Docket Item # 13
BAR CASE # 2009-0184

BAR Meeting
September 16, 2009

ISSUE: Alterations
APPLICANT: T.J. Fannon and Sons
LOCATION: 1200 Duke Street
ZONE: OC/Office Commercial Zone

Figure 8: Brick Wall and Gate Proposal

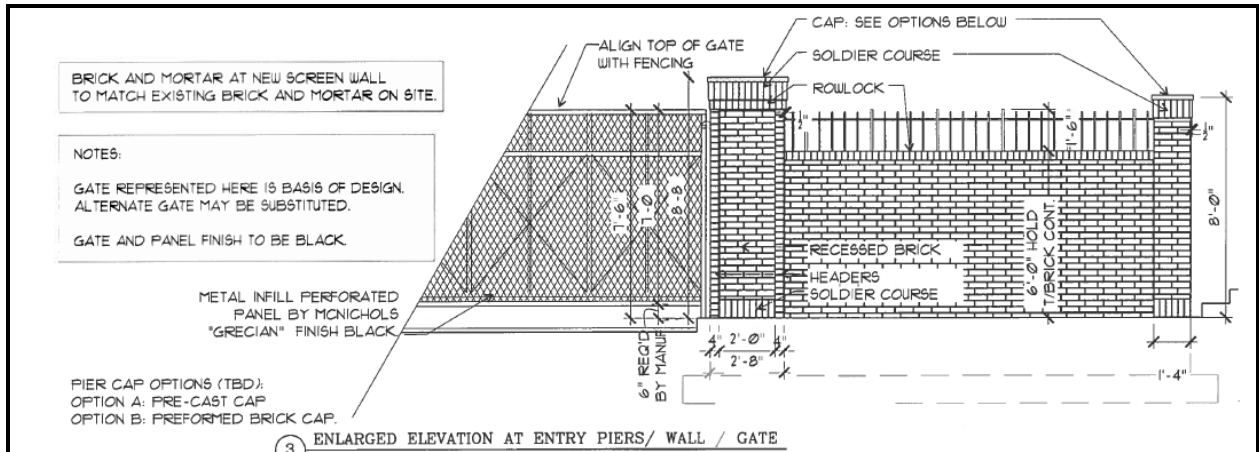
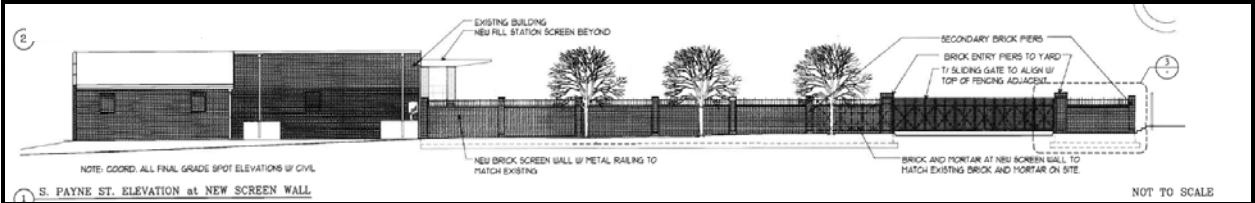
The *Design Guidelines* recommend that: “Fences, garden walls and gates should be appropriate in materials, design and scale to the period and character of the structure they surround.” The *Guidelines* also state that “...important visual features of the historic districts are the fences, garden walls and gates that define property lines”, and “provide a visual barrier.” These “...walls of brick or stone are generally appropriate throughout the historic districts.” While at one time the site was bordered by commercial and industrial uses to the south, west and east, the site is now surrounded by residential uses. Those residential uses are housed in a variety of structures that include historic townhouses on the north side of Duke Street; Old Town Village townhouses and condominiums to the east, south and southeast that were constructed in the mid-1990s; and new townhouses and condominiums presently under construction at the former site of Fannon Petroleum Services, Inc. at 1300 Duke Street. Old Town Village also has a park with children’s play yard that is located to the south, and immediately adjacent to the site. Given the predominantly residential use and mid-scale brick structures that surround the Fannon site, Staff finds that the proposed platform, wall, and gate are attractive and appropriately scaled and detailed.

Enclosing this property’s commercial yard with a brick wall is generally appropriate, as the adjacent properties are residential (multi-family and townhouses) and it will assist in separating, and in some respects unifying the two very different uses along South Payne Street. As the proposed brick wall runs approximately one-hundred-sixty (160’) feet in length along South Payne Street, the wall’s design will be a landscape feature as well as a utilitarian feature. The materials and forms proposed, which are more typical in residential developments, (brick piers with capitals, decorative ironwork gates, wrought iron metal railings etc.) achieves this goal.

The proposed gate is located technically outside the district boundaries, however is integral to the proposed wall. Staff finds the gate appropriate and recommends approval of the gate.

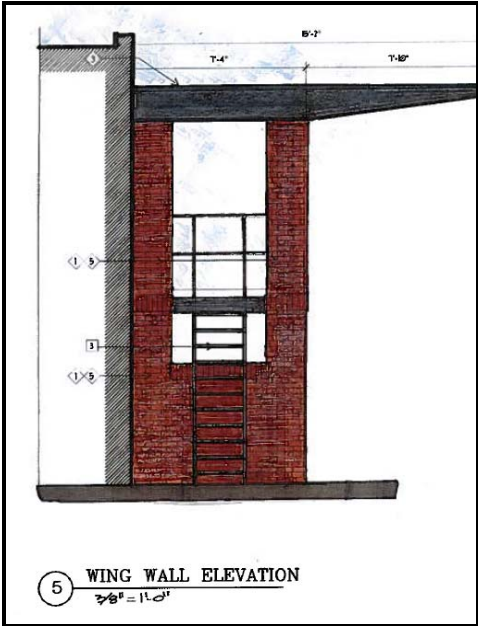
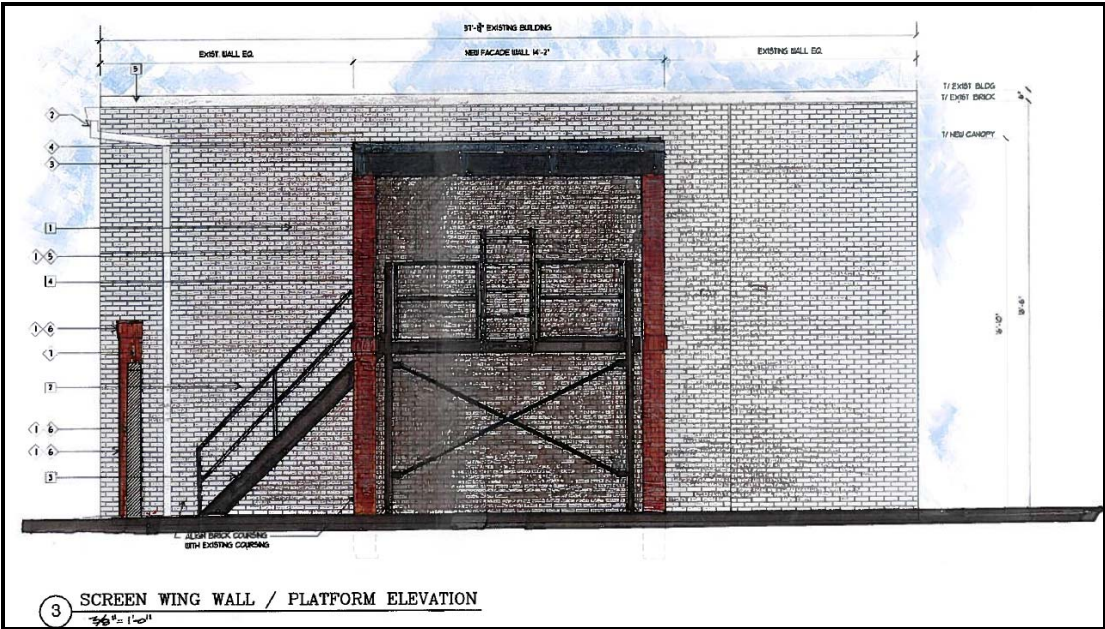
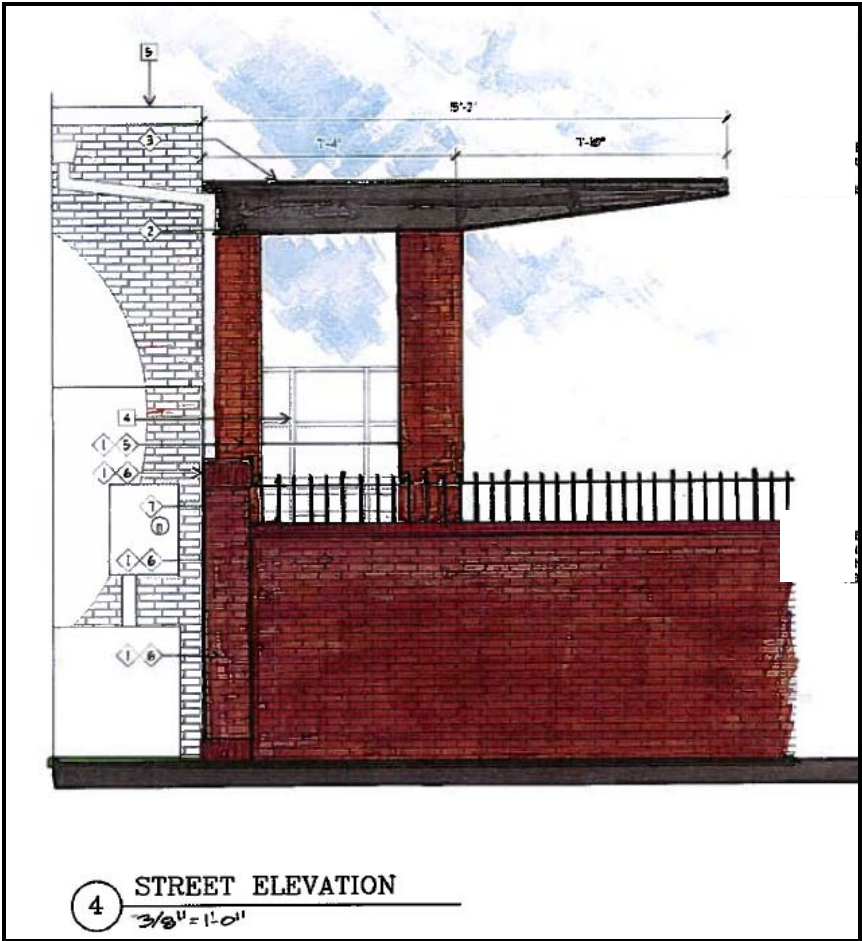
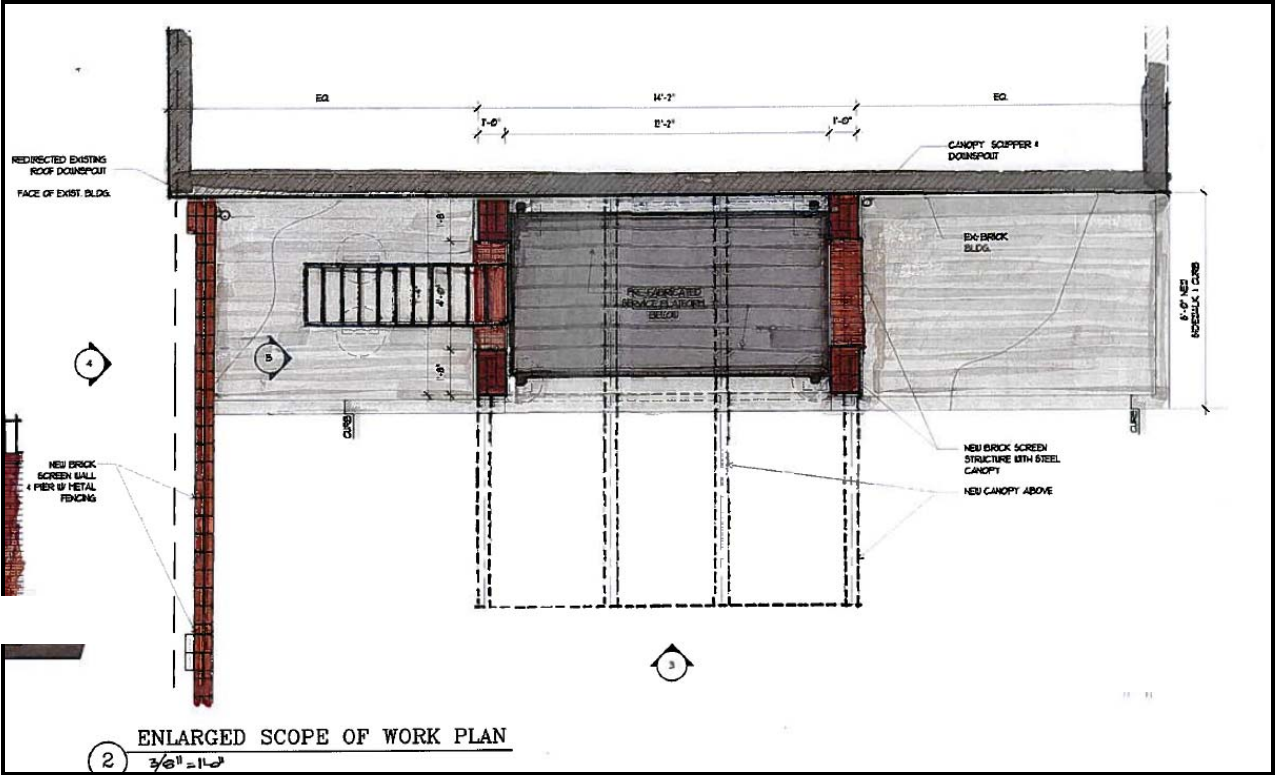
The proposed service platform/filling station will be installed abutting the south wall of the existing garage building. Constructing the heating oil dispensing platform adjacent to the south side of the garage shields open views of the platform from Duke Street, while also locating the heating oil dispensing function as far as possible from the residential uses to the south. The canopy of the heating oil service platform is proposed to be lower in height

than the main garage building. Designing this canopy lower in height differentiates it from the main structure. The materials being proposed for the platform are a corrugated metal roof supported by a steel frame set upon two brick walls that will screen the view from the west and east of the metal dispensing platform. Staff recommends that the platform canopy assembly, roofing material and fasteners will be factory finished or painted to prevent rust.

STAFF RECOMMENDATION: Staff recommends approval of the Certificate of Appropriateness application with the following conditions:

1. That the platform canopy assembly, roofing material and fasteners will be factory finished or painted to prevent rust.
2. The below conditions shall appear in the General Notes of all site plans and on all site plan sheets that involve demolition or ground disturbance (including Erosion and Sediment Control, Grading, and Sheeting and Shoring) so that on-site contractors are aware of the requirements. Additional conditions to be included on the Final Site Plan will be determined in consultation with Alexandria Archaeology.
